Memorandum

SUBJECT: **Te Puawai ITA Addendum No 1 – Response to ICC RFI 1**

Figure A 8: Rural channelised (CH) intersection turn treatments

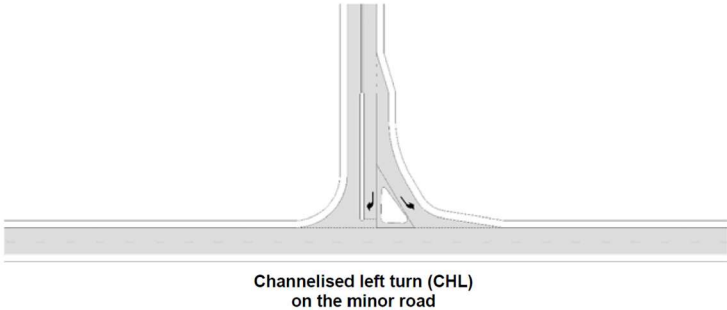
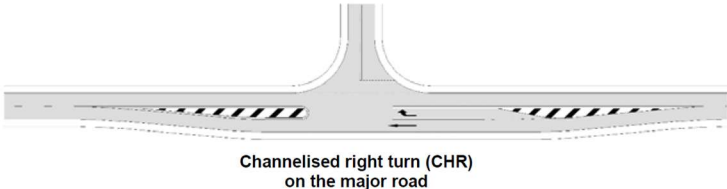
Based on a peak hour traffic volume of 654 veh/h (15% of Rockdale Road AADT) and the estimated left turn and right turn peak hour traffic volumes as shown on Figure 18. AustRoads GTRD Part 4 Fig A10 recommends that a channelised

intersection is required. Either a giveaway controlled intersection with channelisation or a roundabout may be appropriate in this location.

Examples of rural (high speed intersection channelisation) are shown given in Figure A8 of AustRoads and reproduced below
